Access Compliance Report

Public Rights-of-Way

(Island Curb Cuts)

Intersection ID: 28442	Main Street: IDLEWILD_RD	Cross Street: NARAYAN_ST	Location: E
ADA ID: A79343355BA9	Curb Cut Type: MedianRefuge2	Initial Pass/Fail: Fail	Overall Compliance: No
Codes/Mitigation Info/Possible Solution		Field Measurements/Component Compliance	
Severity Score: 25

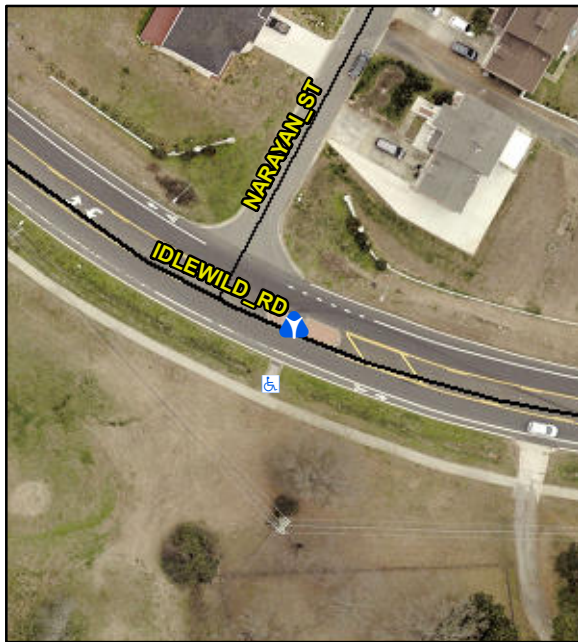
Compliance	Description	Data	Compliance	Description	Data
Yes	Refuge 1 Length (In)	66.0	N/A	Gutter 1 Ponding?	N/A
Yes	Refuge 1 Width (In)	120.0	N/A	Gutter 1 Lip Ht (In)	N/A
No	Refuge 1 Slope (%)	6.0	N/A	Gutter 1 Slope (%)	N/A
No	Refuge 1 X Slope (%)	5.4	N/A	Gutter 1 X Slope (%)	N/A
N/A	Painted X Walk1?	No	N/A	DWS 1 Provided?	N/A
N/A	X Walk 1 Direction	To N	N/A	DWS 1 Contrast?	N/A
N/A	X Walk 1 Width (In)	N/A	N/A	DWS 1 Length (In)	N/A
N/A	Road 1 Slope (%)	4.5	N/A	DWS 1 Full Width?	N/A
N/A	Road 1 X Slope (%)	8.6	N/A	DWS 1 Offset (In)	N/A
Yes	Refuge 2 Length (In)	66.0	N/A	Gutter 2 Ponding?	N/A
Yes	Refuge 2 Width (In)	120.0	N/A	Gutter 2 Lip Ht (In)	N/A
No	Refuge 2 Slope (%)	6.4	N/A	Gutter 2 Slope (%)	N/A
Yes	Refuge 2 X Slope (%)	4.7	N/A	Gutter 2 X Slope (%)	N/A
N/A	Painted X Walk2?	No	N/A	DWS 2 Provided?	N/A
N/A	X Walk 2 Direction	To S	N/A	DWS 2 Contrast?	N/A
N/A	X Walk 2 Width (In)	N/A	N/A	DWS 2 Length (In)	N/A

N/A	Road 2 Slope (%)	4.9	N/A	DWS 2 Full Width?	N/A
N/A	Road 2 X Slope (%)	5.5	N/A	DWS 2 Offset (In)	N/A
N/A	Refuge 3 Length (in)	N/A	N/A	Gutter 3 Ponding?	N/A
N/A	Refuge 3 Width (in)	N/A	N/A	Gutter 3 Lip Ht (in)	N/A
N/A	Refuge 3 Slope (%)	N/A	N/A	Gutter 3 Slope (%)	N/A
N/A	Refuge 3 XSlope (%)	N/A	N/A	Gutter 3 XSlope (%)	N/A
N/A	Painted X Walk3?	N/A	N/A	DWS 3 Provided?	N/A
N/A	X Walk 3 Direction	N/A	N/A	DWS 3 Contrast?	N/A
N/A	X Walk 3 Width (in)	N/A	N/A	DWS 3 Length (in)	N/A
N/A	Road 3 Slope (%)	N/A	N/A	DWS 3 Full Width?	N/A
N/A	Road 3 XSlope (%)	N/A	N/A	DWS 3 Offset (in)	N/A
Yes	Any Obstructions?	N/A	N/A	Storm Grate/Utility Hazard?	N/A
N/A	Obstruction Type		N/A	Storm Grate/Utility Type	
		N/A			N/A
N/A	Surface Condition	Good

Remove & Replace Entire Refuge.
